SAS SUPERSTRUCTURE CONDUIT - PLAN

CONTRACT CHANGE ORDER NO. 42
 SHEET _____ OF _____

SAS SUPERSTRUCTURE ROADWAY EASTBOUND LIGHTING AND ELECTRICAL SYSTEMS

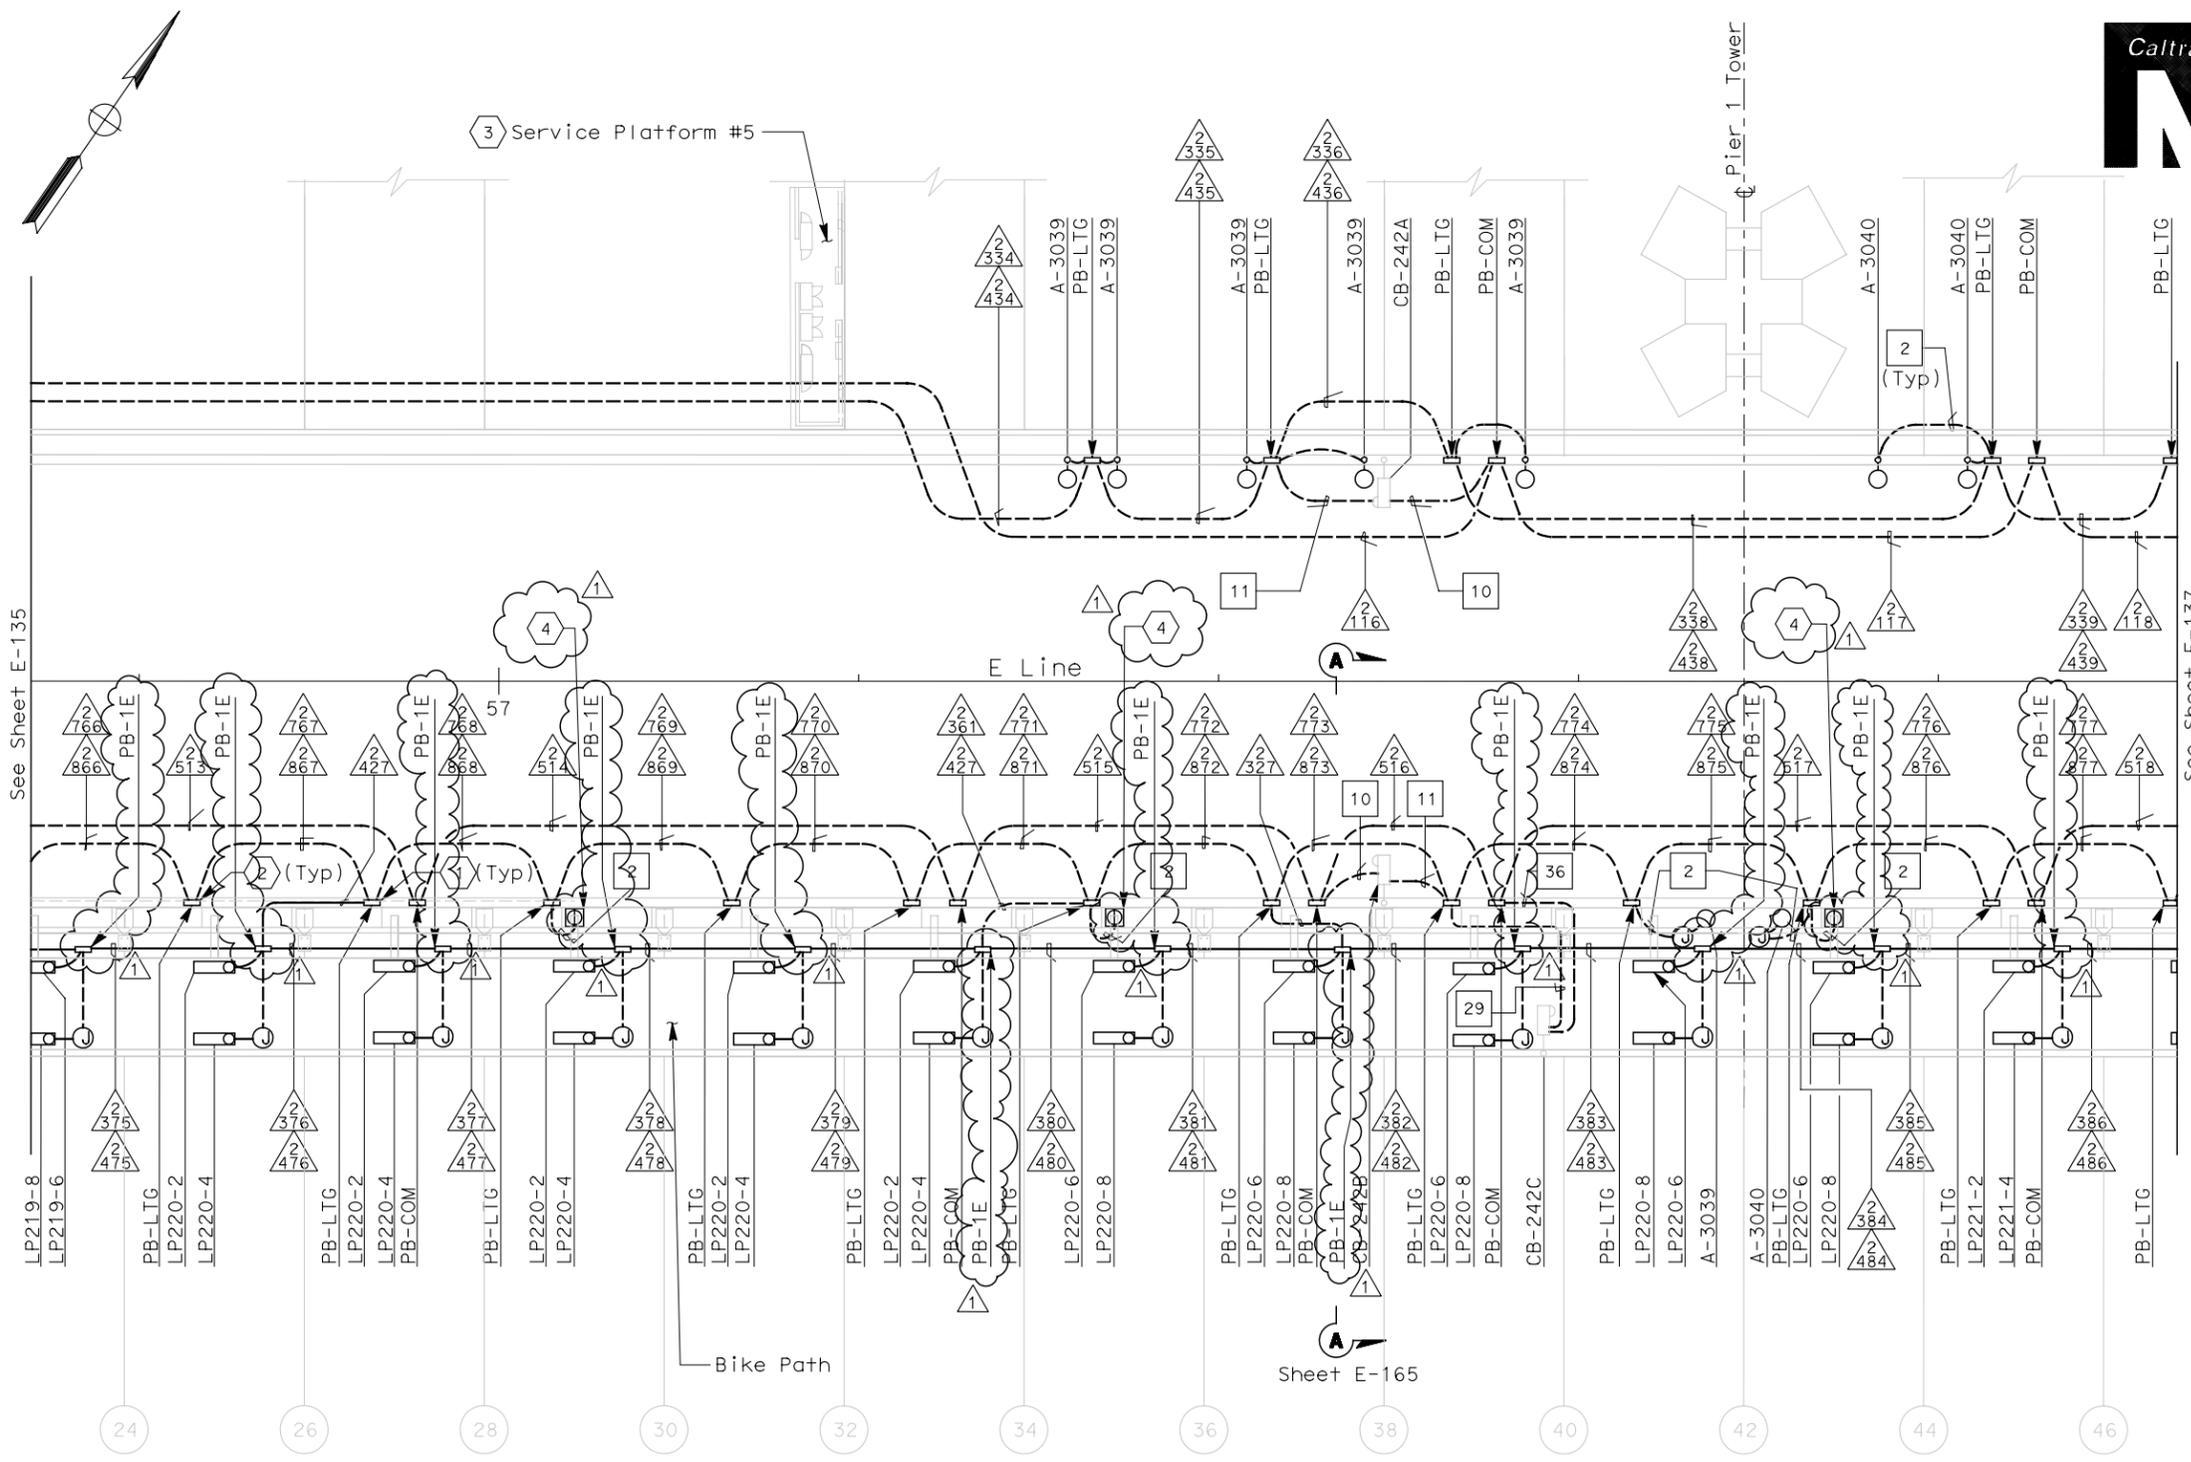
MARK	DATE	DESCRIPTIONS	BY	CK	CCO	
1	8-06-07	Electrical modifications.	MP	EL	RR	42
REVISIONS
